Addendum No. 3

Re: Mobile Alabama Cruise Terminal
Parking Deck Repairs
Project #CT-009-24

Date: February 20, 2025

SHEET TITLE: GENERAL NOTES

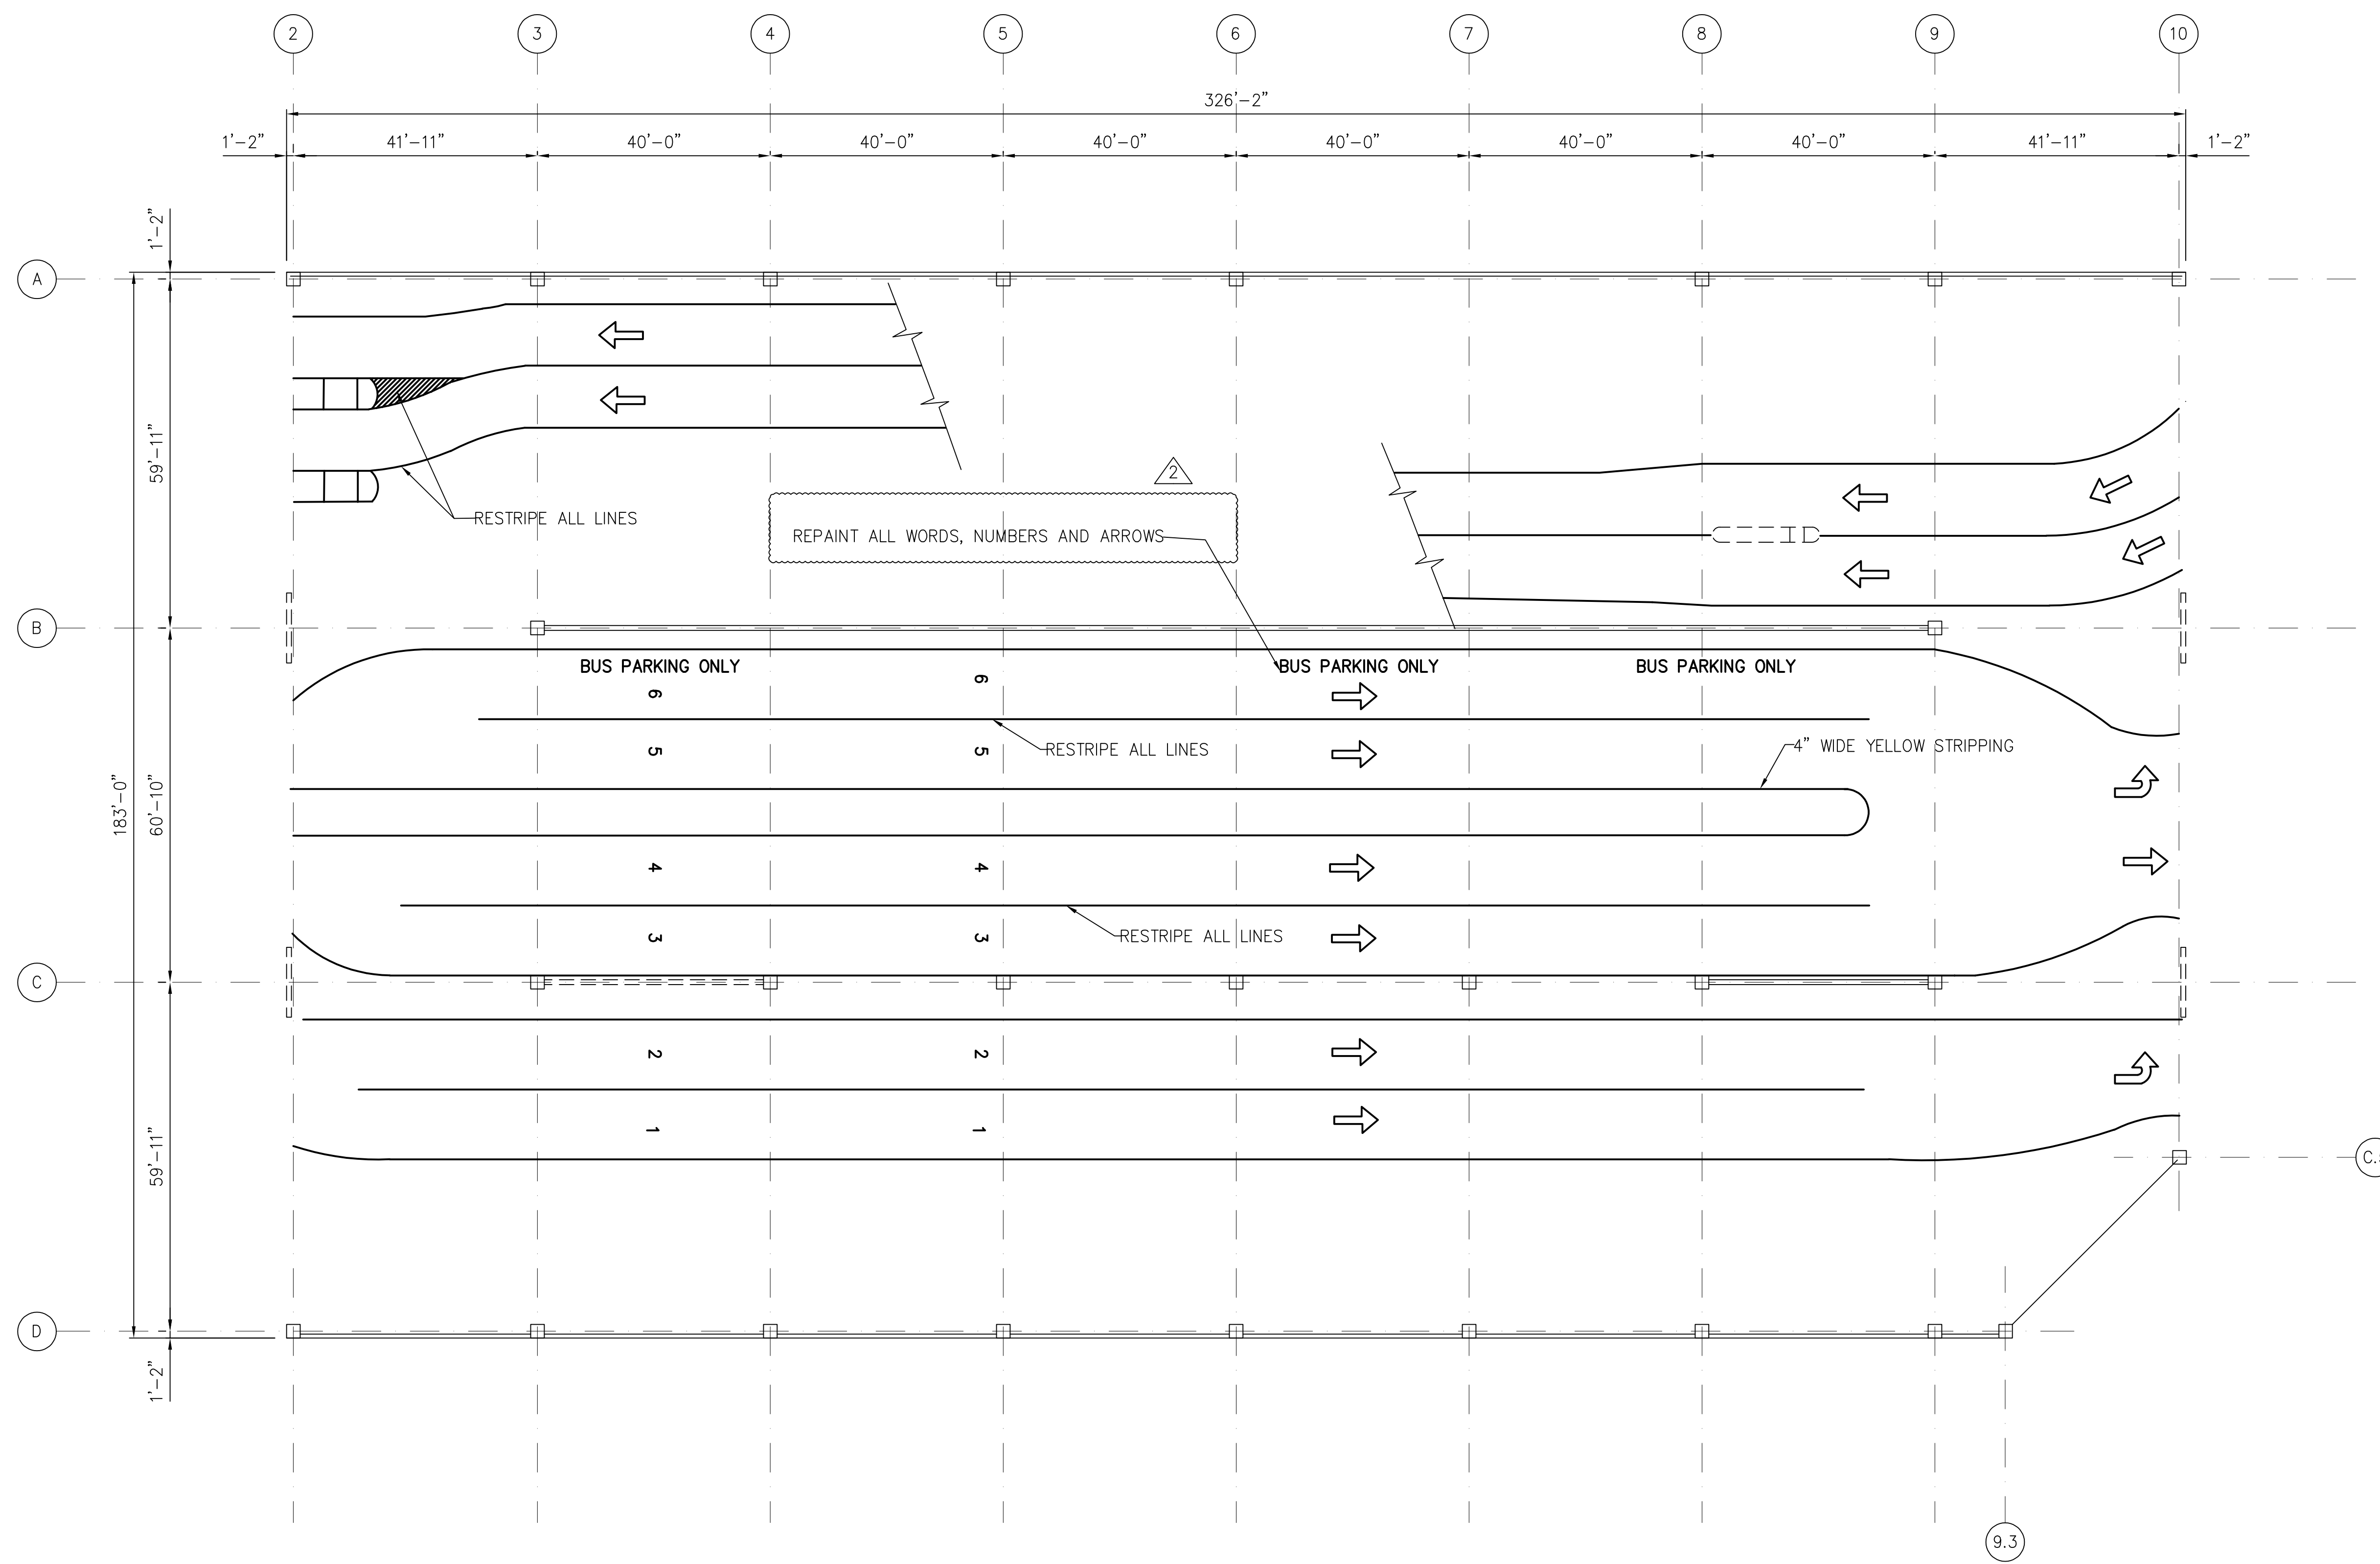
S0.0 General Notes

Item 1 Upper left corner, "Scope of Work": remove "Scope of Work" section from the Issue for Bid set and replace with the "Scope of Work" section clouded and flagged as Revision #2.

Item 2 Center left side, under "Repair Procedures": remove Keynote H from the Issue for Bid set and replace with Keynote H clouded and flagged as Revision #2.

Item 3 "Typical Repairs" Note above photo column: Add clarifying note clouded and flagged as Revision #2.

Item 4 Right hand side of page, under "Washing Methods": Remove Keynote A from the Issue for Bid set and replace with Keynote A clouded and flagged as Revision #2.

Question 5: Plan Sheet S0.0, Scope of Work, item 1.6 – Is this scope intended to be part of this project? There are no specifications or details to accompany this note. Furthermore, it is not listed in Section 01010 “Summary of the Work” as a scope item. This would be a large-ticket item if so. Please clarify.

- Question 9: Plan Sheet S0.0, Repair Procedure “G” – Where is this located? Does this repair item correlate with the below question?
- Answer: Reference Photo 3-1, S0.0. For use there and in similar locations should any exist.

- Answer: Delete this Specification Section 01220 Unit Prices from specifications. There are no unit prices on this project.
- Question 11: Plan Sheet S0.0 vs. Plan Sheet S3.1, Repair Procedure “J” – One note reads 24” past either side, and the other reads 12” past. Please clarify.

Answer: No, this work is not included. See revised drawings and specifications.

- Answer: Use 24”
- Question 12: Plan Sheet S0.0, Repair Products – The repair mortar “Mapei Planitop XS” is a vertical/overhead repair mortar & is intended horizontally for light foot traffic only, per the product data sheet. Is there an alternative product that is recommended for vehicular traffic?

1st LEVEL PARKING DECK TRAFFIC MARKINGS
SCALE: 1/16"=1'-0"

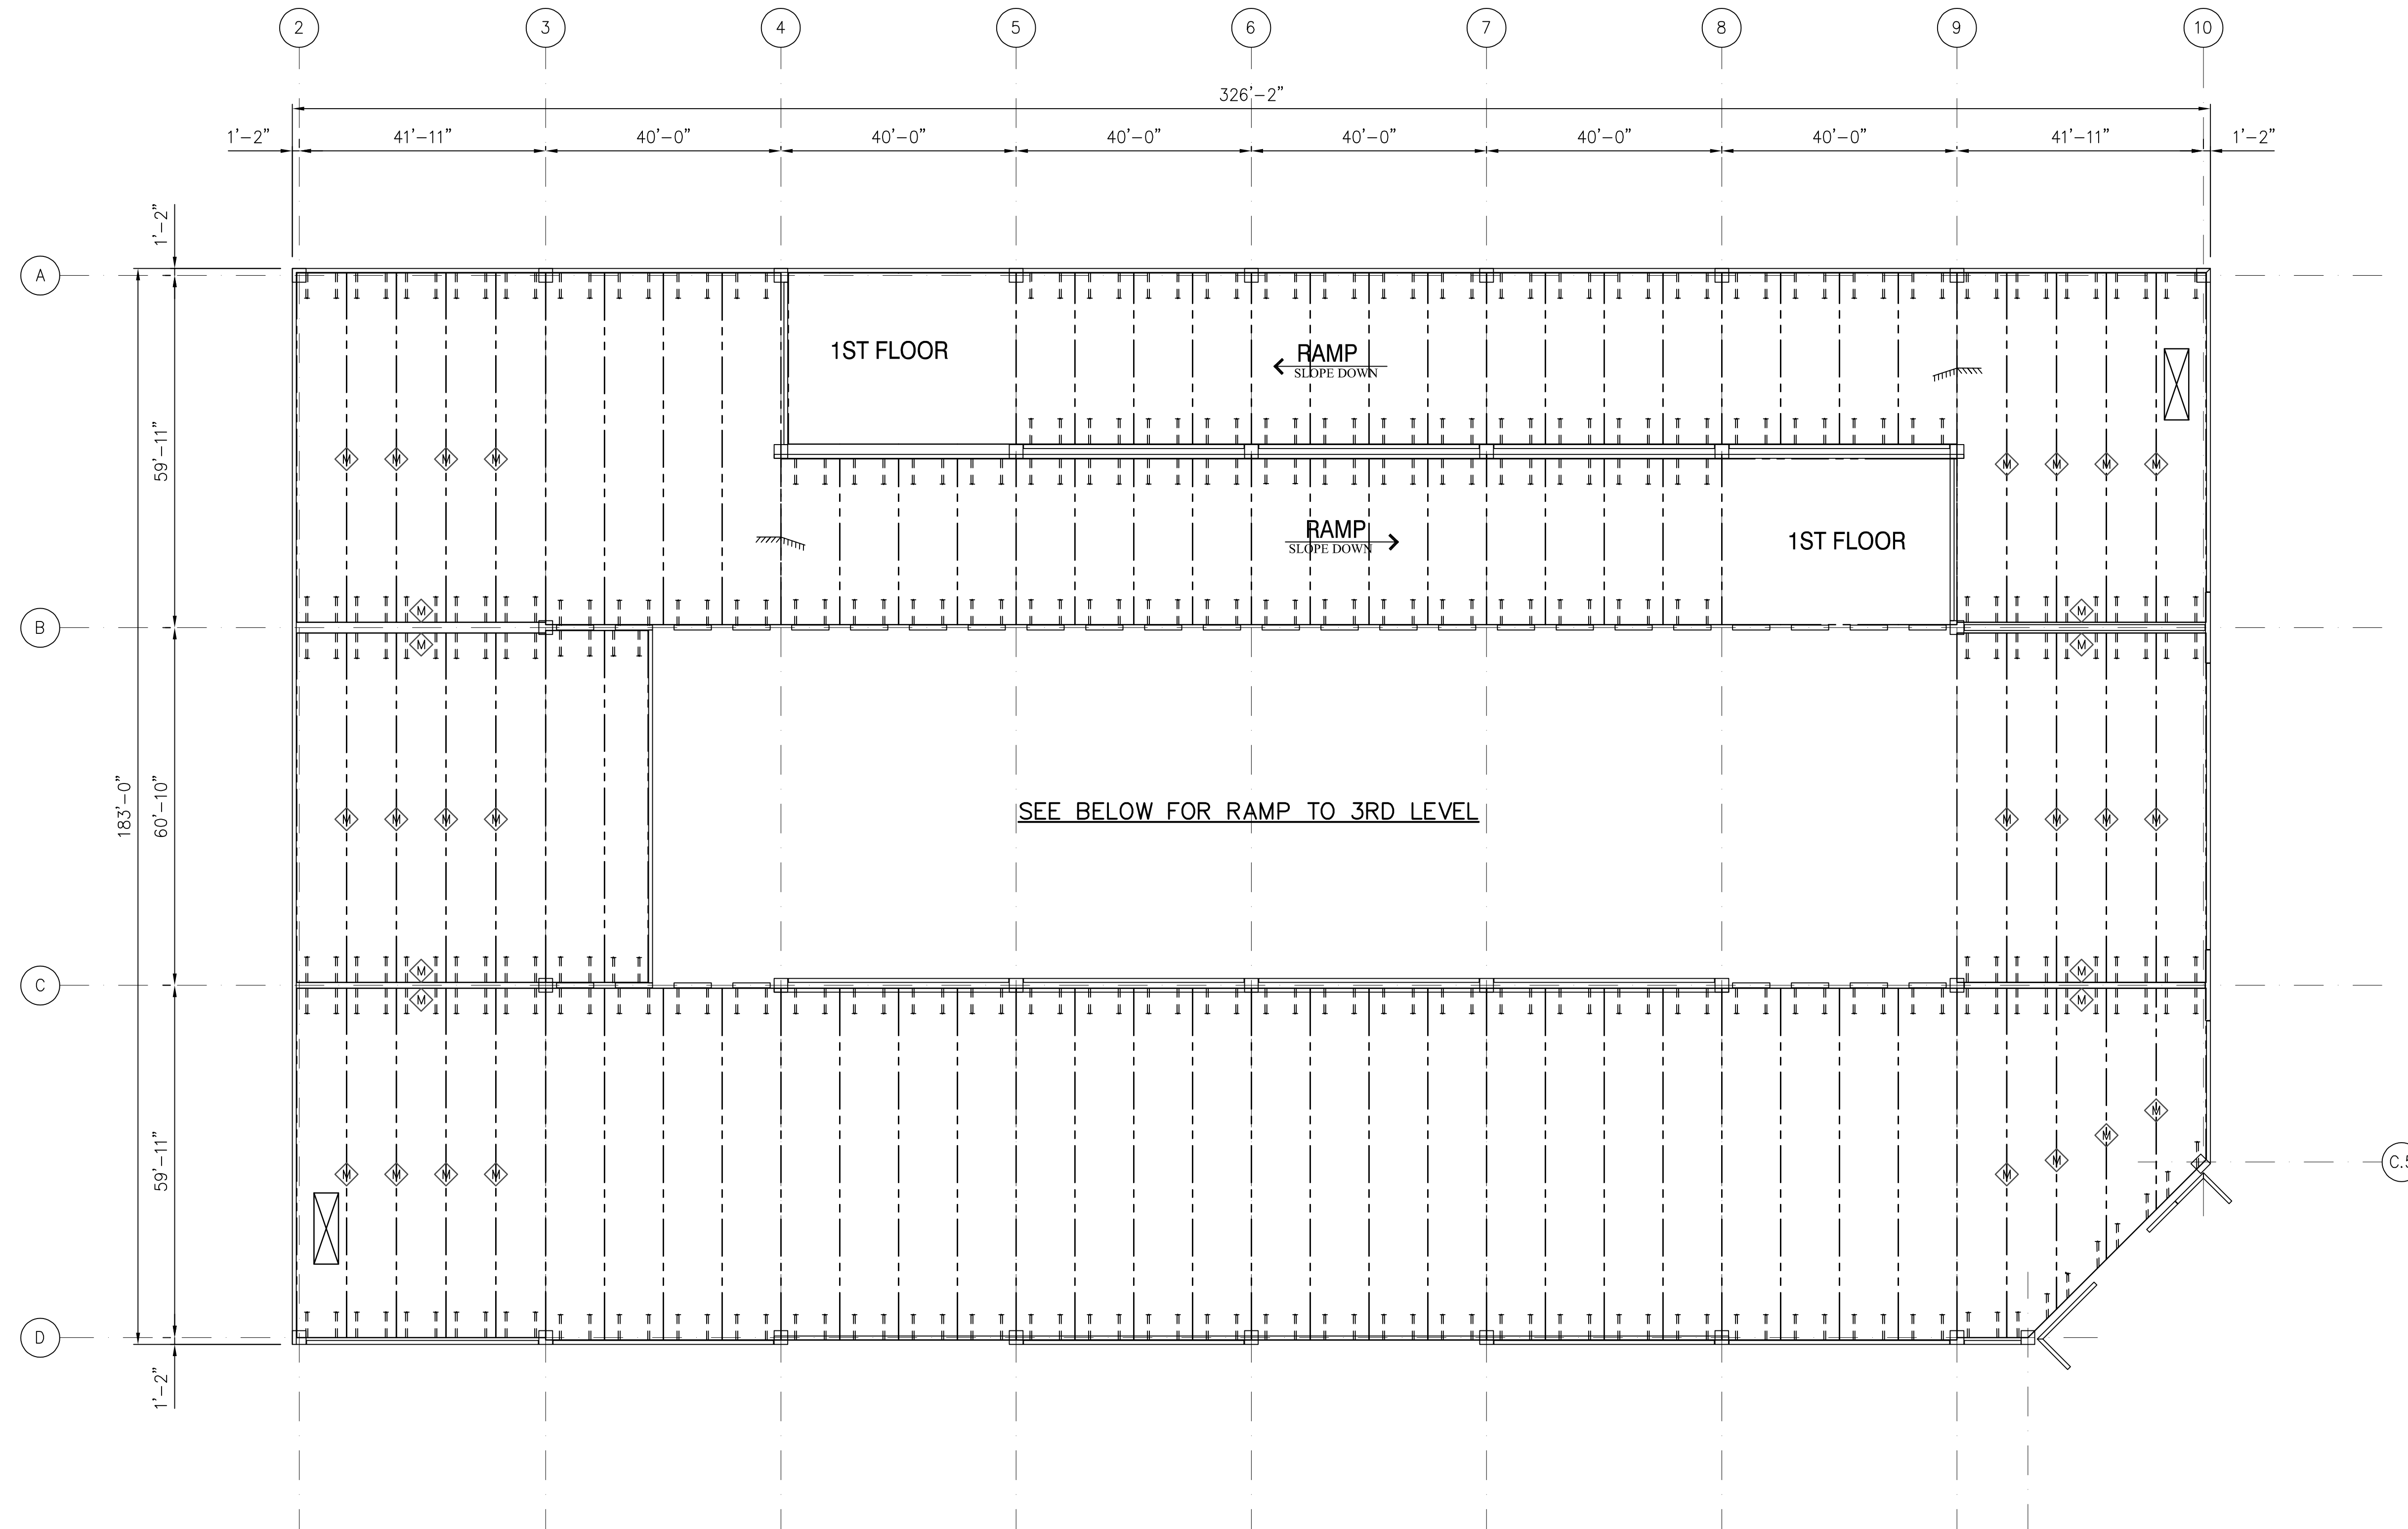
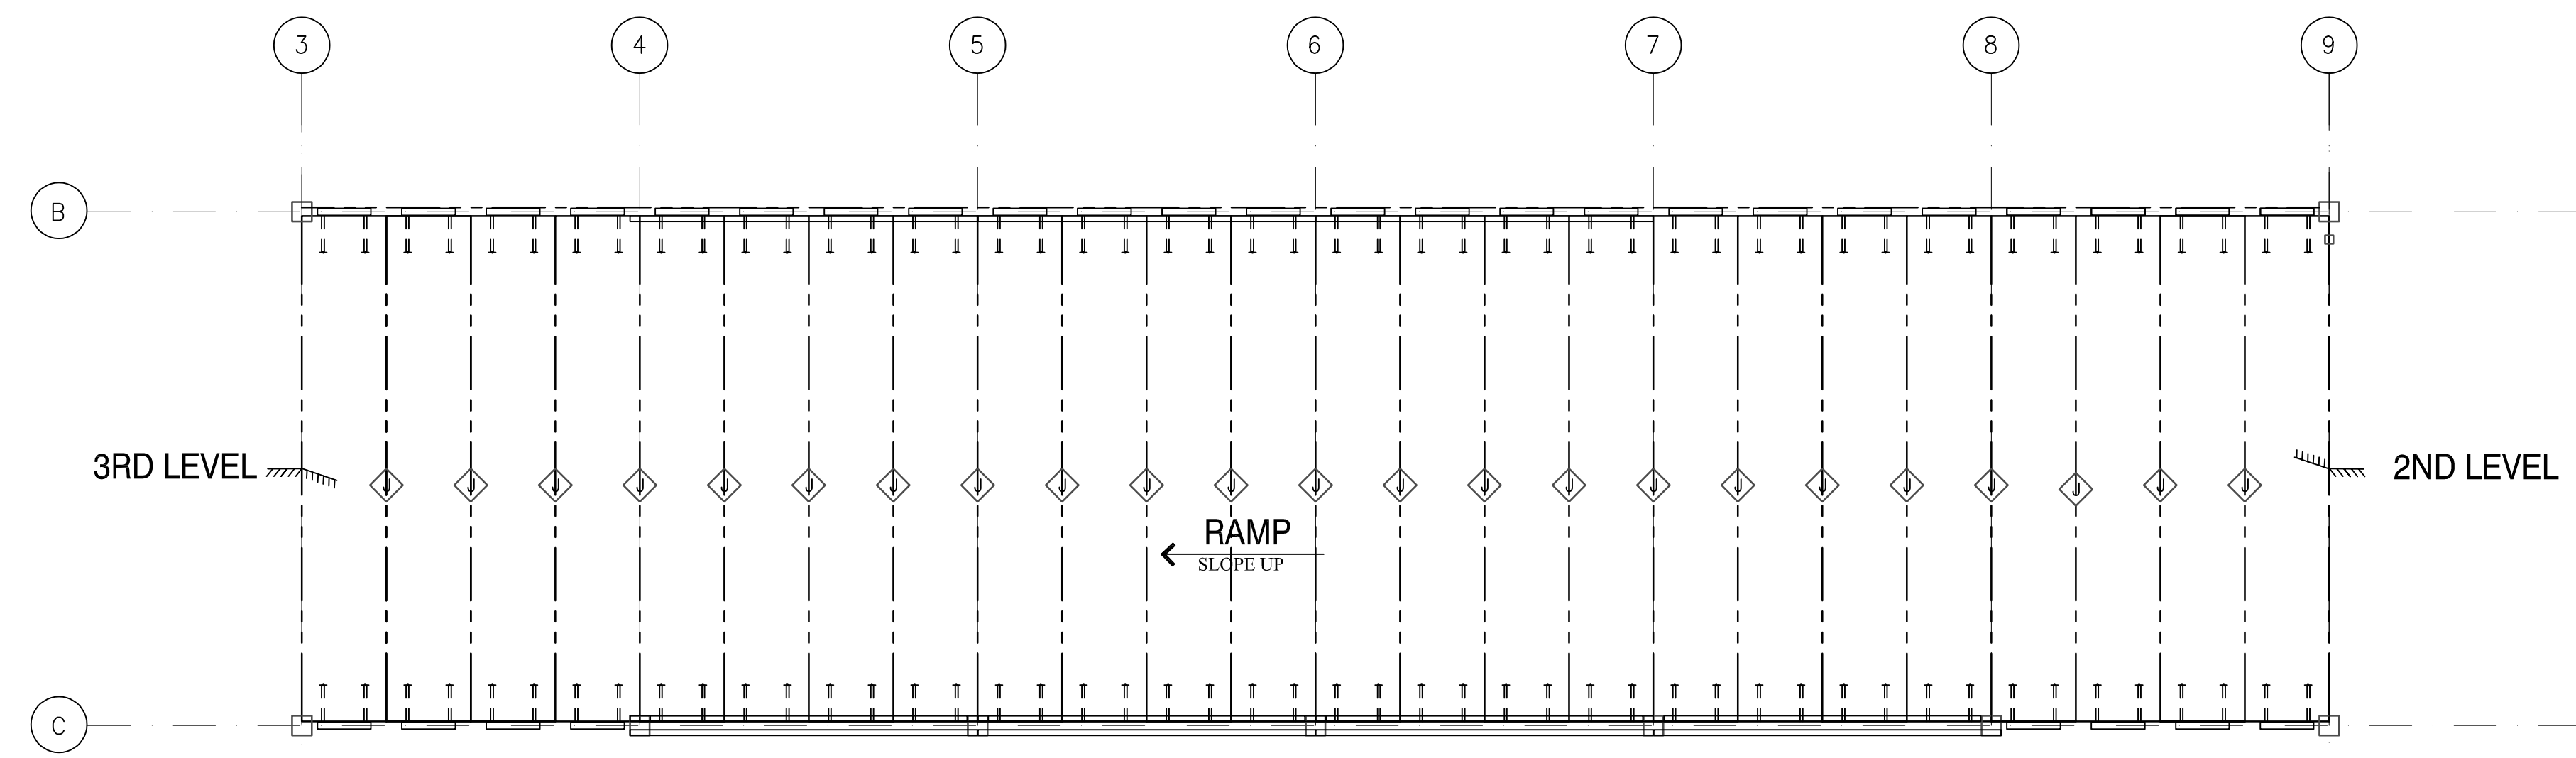
S1.1 First Floor Traffic Markings

Item 1 Right hand side of page, remove Keynote 1 from the Issue for Bid set and replace with Keynote 1 clouded and flagged as Revision #2.

Item 2 Center of page: added clarifying note clarifying scope of traffic painting as clouded and flagged as Revision #2.
